DOCUMENT 00911

ADDENDUM NUMBER 1

Issued: Tuesday, September 13, 2016

Ralphine Tanks Flow-Through Conversion

SCALE: AS SHOWN	DATE: 9/13/2016	RALPHINE TANKS FLOW THROUGH CONVERSION	
DRAWN: ADF	REVIEWED:	CHAIN LINK FENCE AND GATE DETAILS	
FILE NAME: 7735_D-5.dwg	DRAWING NUMBER: D-6	SHEET 10 OF 13	
CONTRACT NUMBER: 60-67-7 #4

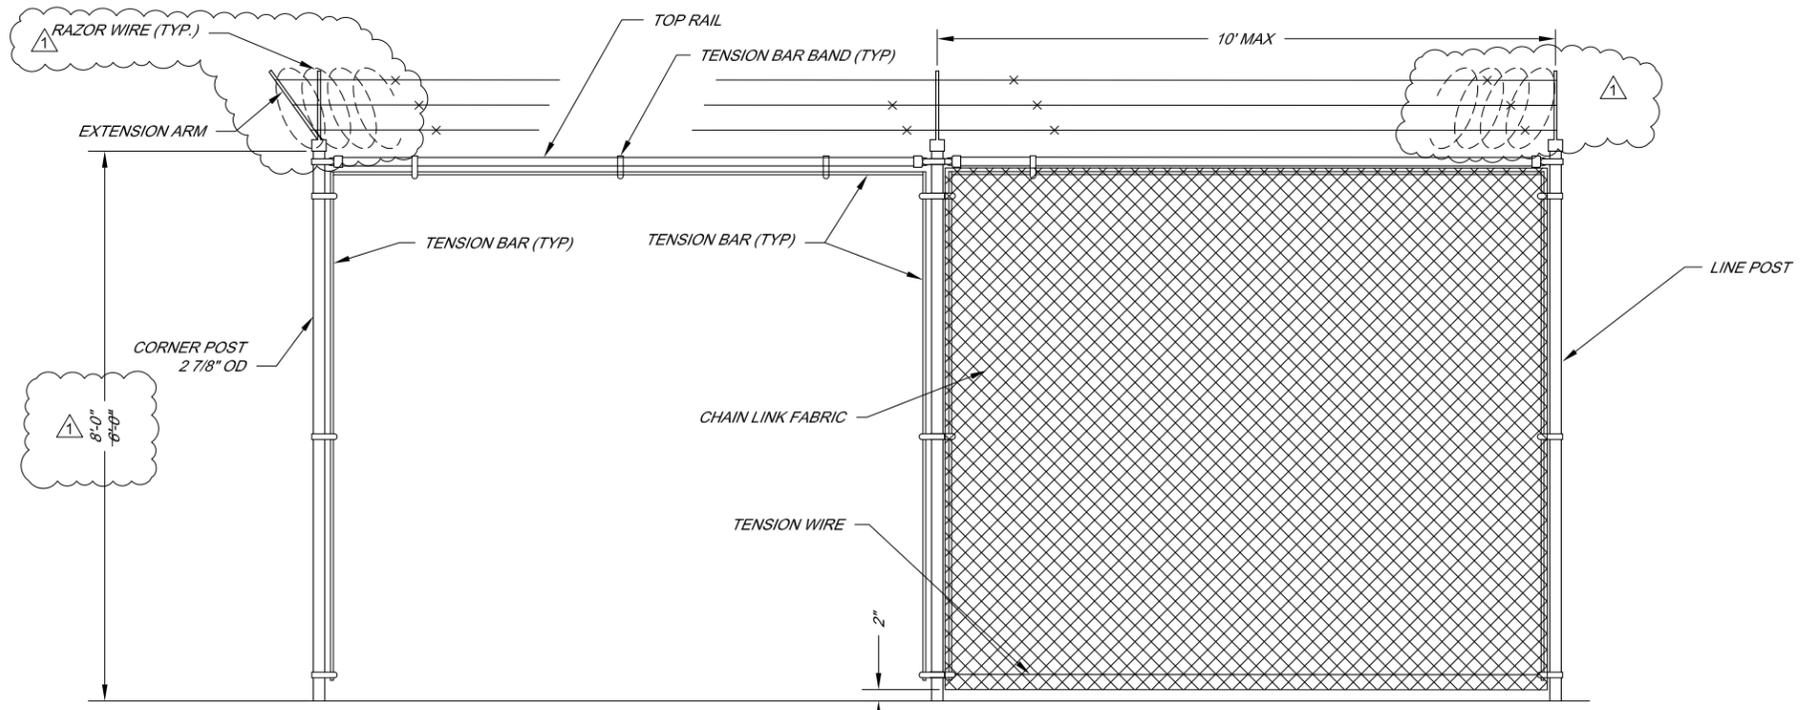
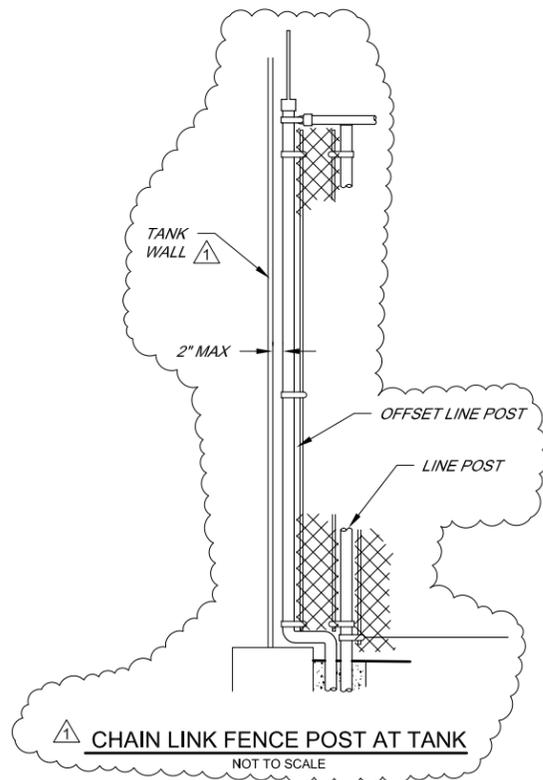
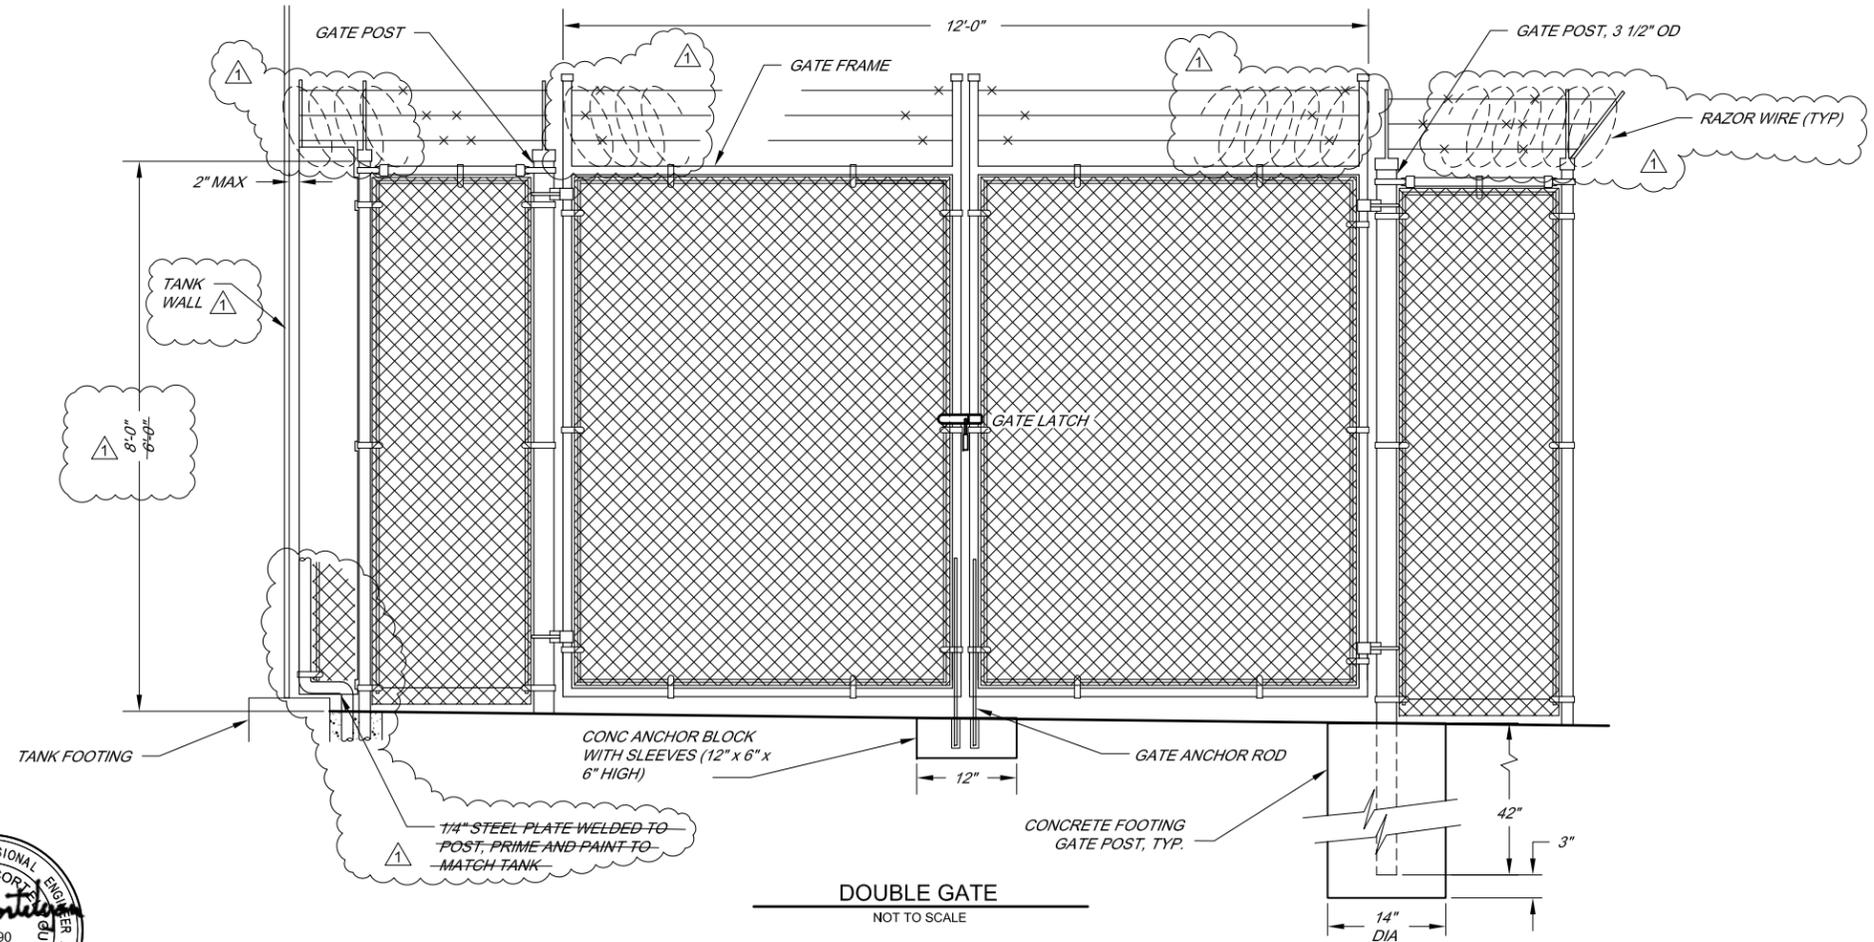
- A. Drawing No. C-3: For all references to 6' high chain link gate and 6' chain link fence: delete "6" and replace with "8"
- B. Delete Drawing No. D6 and replace with revised Drawing No. D6 attached and marked "9/13/16 Addendum 1"
